ADDENDUM NO. 1
PROJECT MANUAL
CITY OF CORSICANA
CORSICANA, TEXAS
2026 AIRPORT ELECTRICAL IMPROVEMENTS
TXDOT CSJ NO. 2618CORSI

This Addendum to the Project Manual is issued to modify, explain, or correct the original Contract Documents and Specifications for the 2026 Electrical Improvements (TXDOT CSJ No. 2618CORSI) and is hereby made part of the Contract Documents. Acknowledgement of receipt of the Addendum is required on the signature page of the Bid Form. Failure to acknowledge all addenda could render your Bid out of form and result in a non-responsive Bid.

ELECTRICAL PLAN - V

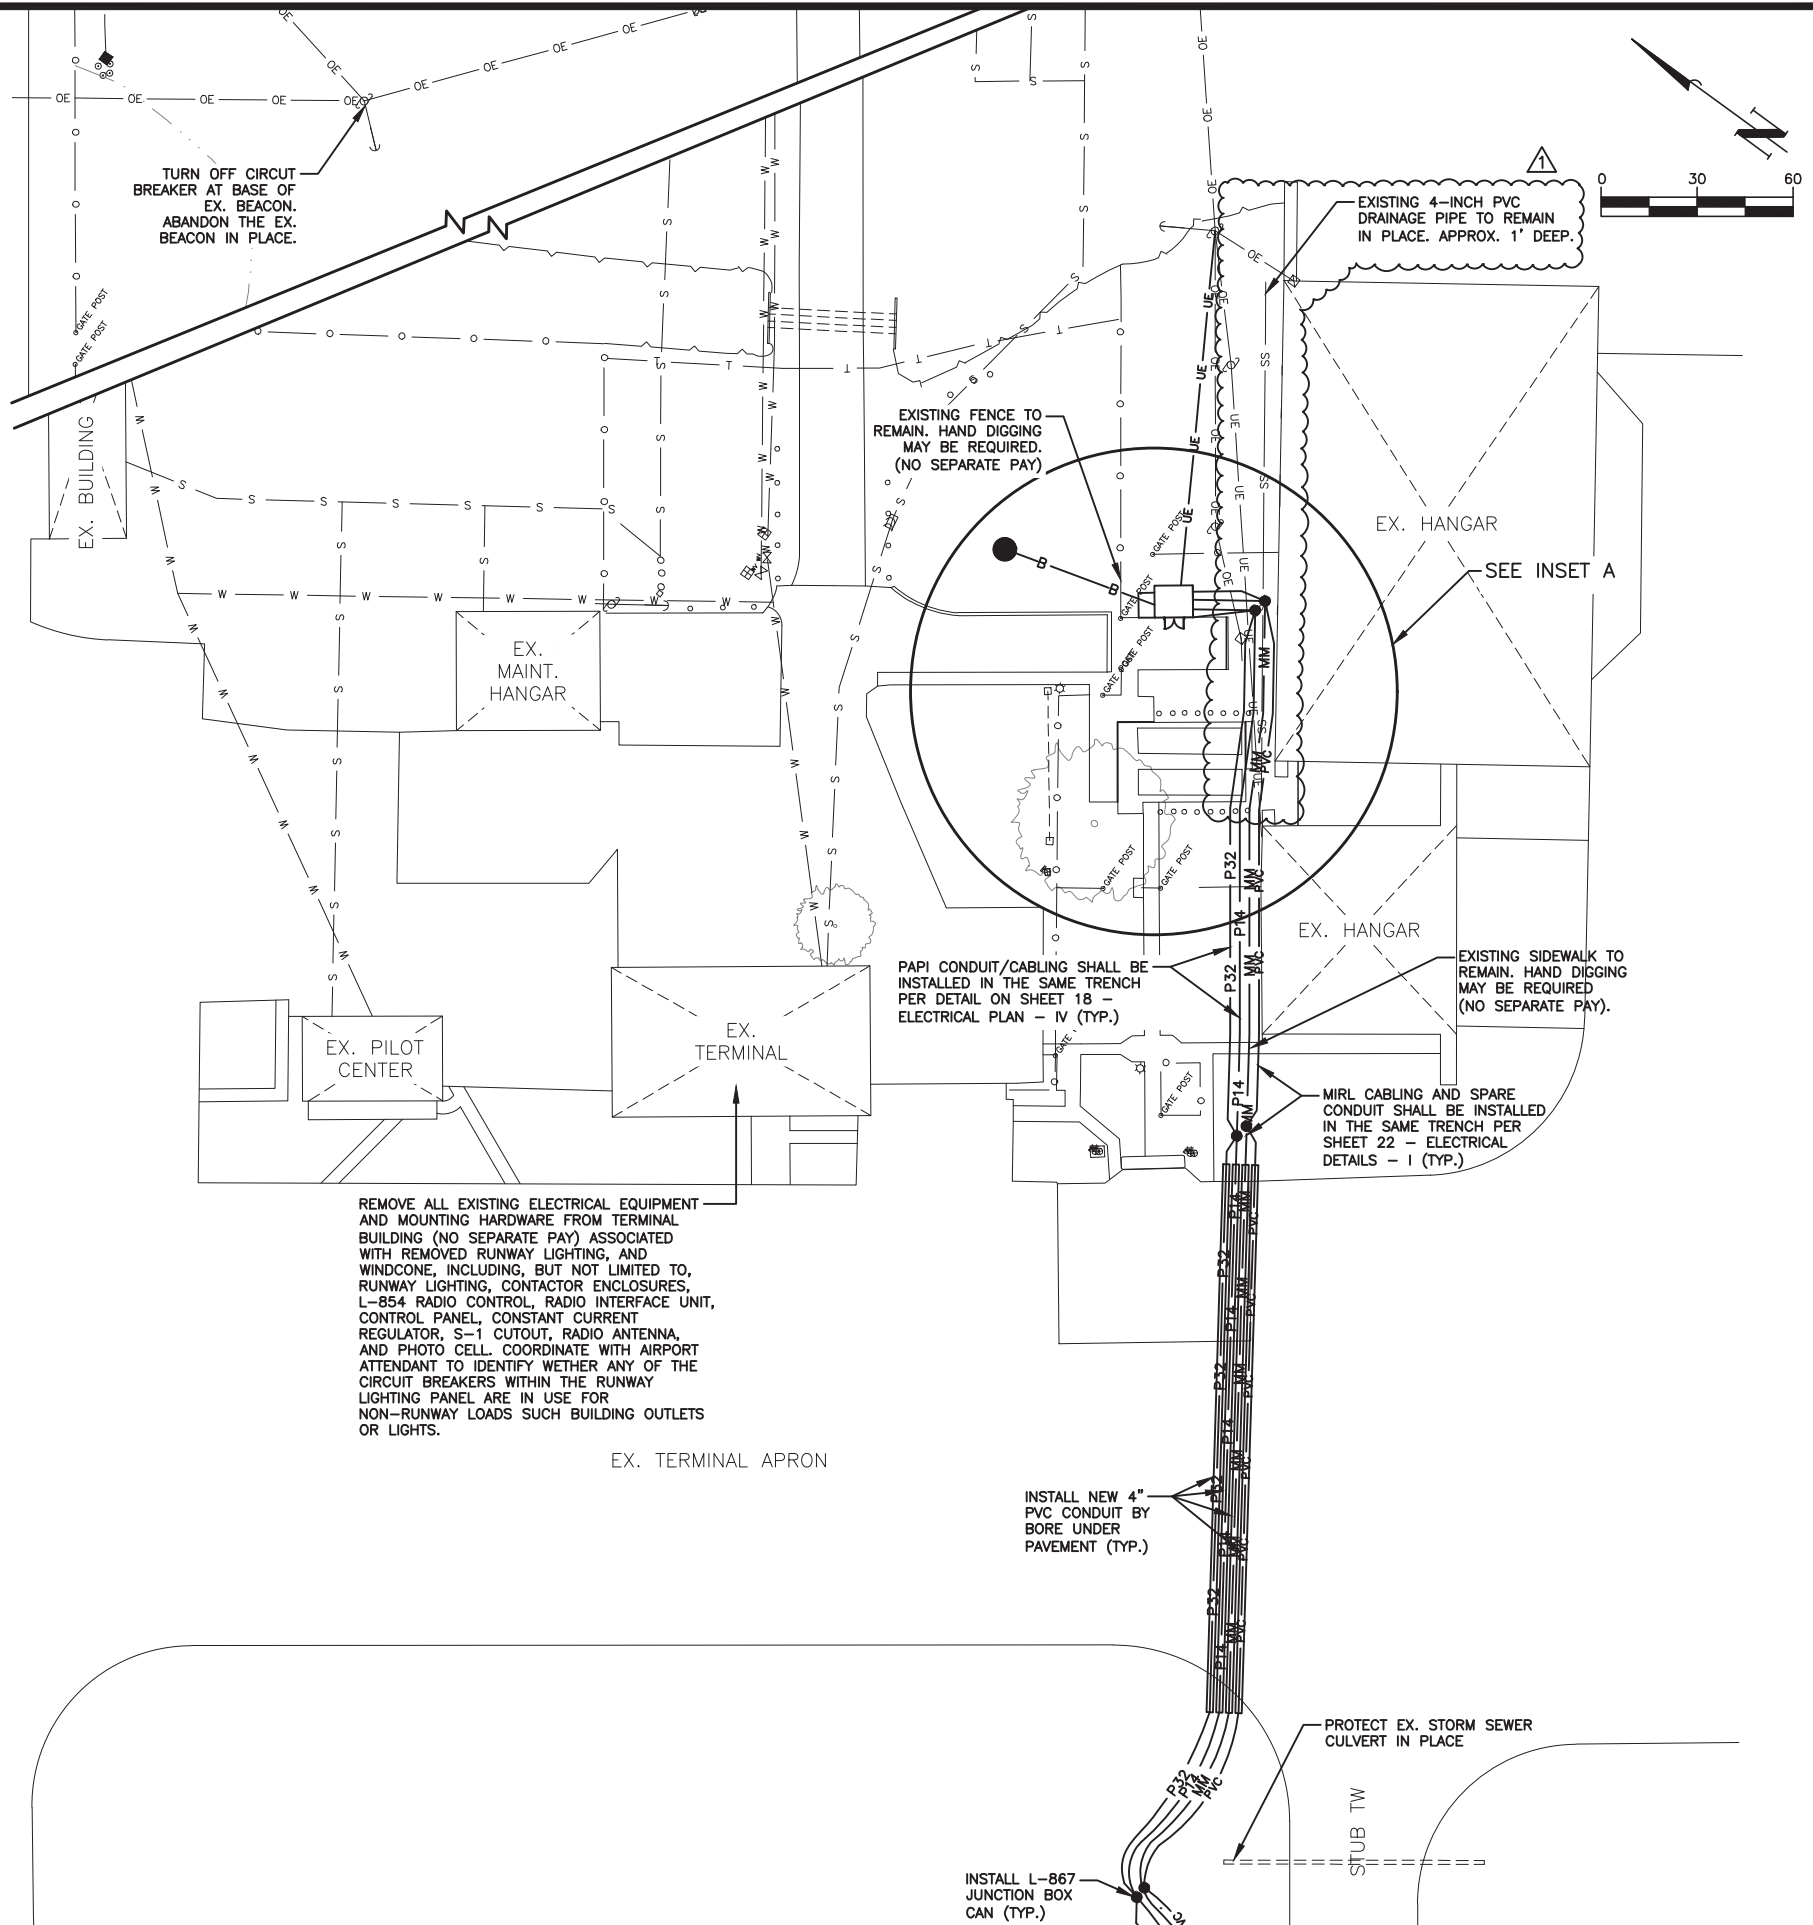
- i. Engineer noted that Drawing Sheet No. 19 will be updated to show an additional drainage line.
- j. A contractor asked whether a one-line diagram would be provided for an arc flash study. Engineer indicated that a separate one-line diagram would not be provided but indicated the power distribution system consists of the following: Incoming utility power is connected to the vault through the outdoor meter socket, and main breaker disconnect shown on the "vault section view-exterior backwall" detail is on Drawing Sheet No. 27. Power is then connected from the outdoor main breaker disconnect to the indoor 120/240-volt (V) panel shown as Item No. 3 on the vault views on Drawing Sheet No. 27. The circuit diagram for the indoor 120/240-V panel and the remainder of the power distribution system is shown on the typical wiring diagram on Drawing Sheet No. 28.

REPLACE Sheet No. 19 with the attached revised Sheet No. 19.
